Department of
Primary Industries
Office of Water

**PLANNING PROPOSAL – “KYEEMA” GUNDAROO ROAD,
GUNDAROO (PP-2012-03)**

I refer to your letter dated 13th November 2013 requesting comments on the planning proposal to rezone land known as “Kyeema” at Gundaroo from RU1 primary production to RU5 village with minimum lot sizes of 2000sqm and 1 hectare, and part E3 Environmental Management. The NSW Office of Water appreciates the opportunity to comment and requests the following comments be considered in finalising the proposal.

Environmentally Sensitive Areas - Sensitive Water Resources & Groundwater Bores

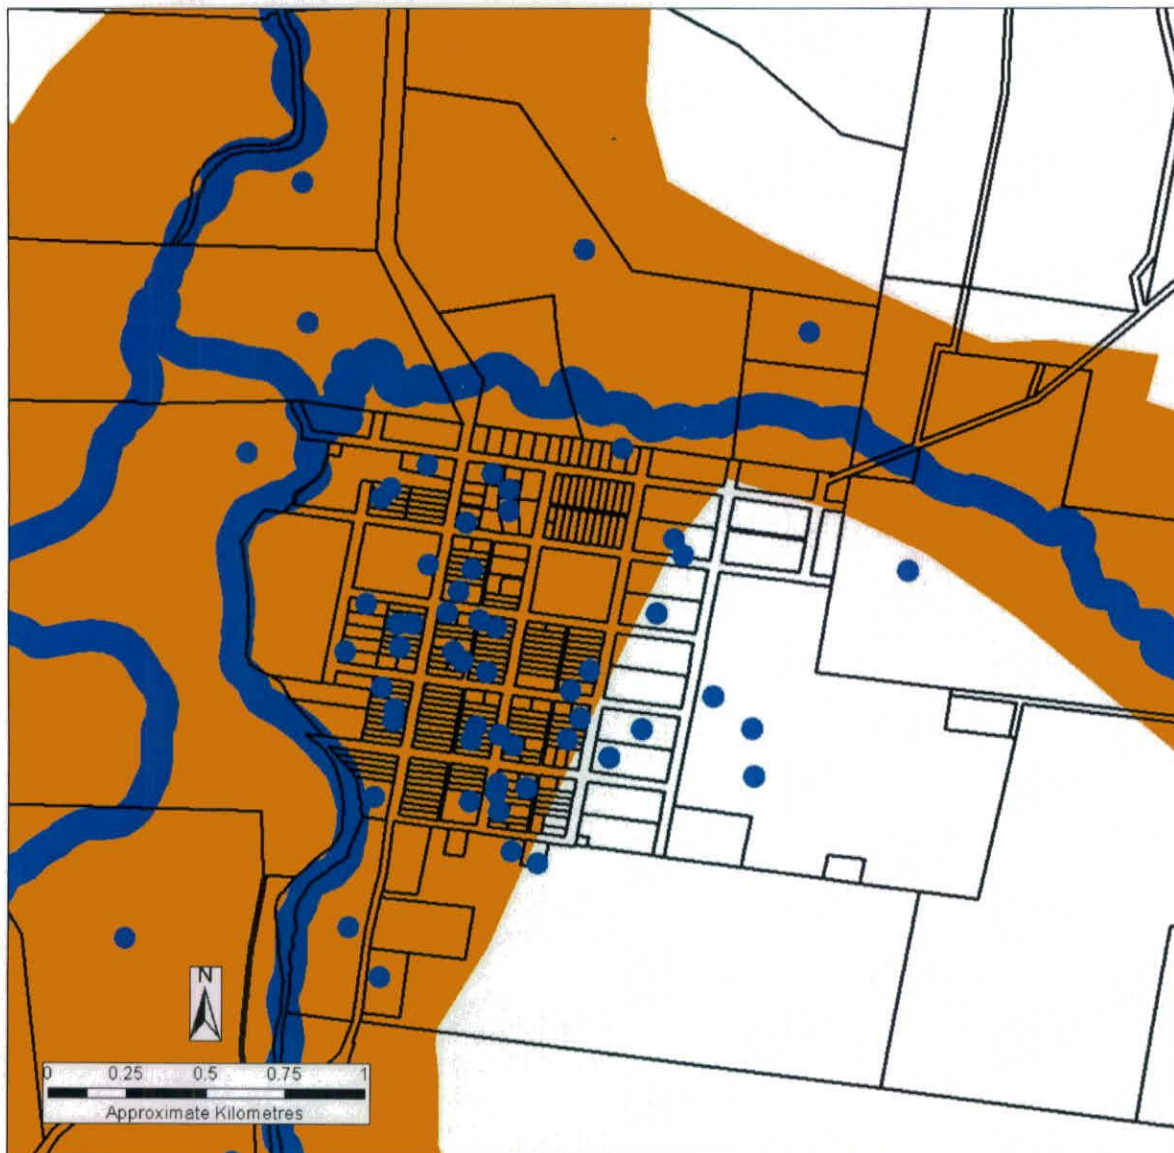
- The proposed site is characterised by moderately-high groundwater vulnerability and the Office of Water’s groundwater database shows records of groundwater levels in the local area ranging from 7-20m below ground. Rezoning the area to RU5 Village may lead to a concentration of basic landholder right bores for domestic and stock purposes from the subdivision of the land into smaller rural residential allotments. This creates the potential risk for groundwater contamination from irrigated effluent entering the preferential pathways of the fractured rock geology and likely pumping interference between users.

- It is recognised McLeods Ck, a third order watercourse, traverses the southern portion of the subject land. NOW supports the proposed 100m buffer between McLeods Ck and effluent application areas. It is recommended a 40m buffer be maintained between the dam and the effluent application areas in accordance with the guideline, "On-site Sewage Management for Single Households (1998)".
- The NSW Office of Water advises future watercourse crossing design and other works within 40m of McLeods Ck will need to address the "Guidelines for Controlled Activities on Waterfront Land". These guidelines can be accessed at the following link: <http://www.water.nsw.gov.au/Water-Licensing/Approvals/Controlled-activities/default.aspx>

1. A minimum buffer distance of 250m between all existing and new domestic and stock bores and effluent irrigation areas or sewage disposal sites. This distance is stated within Clause 38(1a) of the *Water Sharing Plan for the Murray Darling Basin Fractured Rock Groundwater Sources 2011* and the "On-site Sewage Management for Single Households (Environment & Health Protection Guidelines, 1998)".
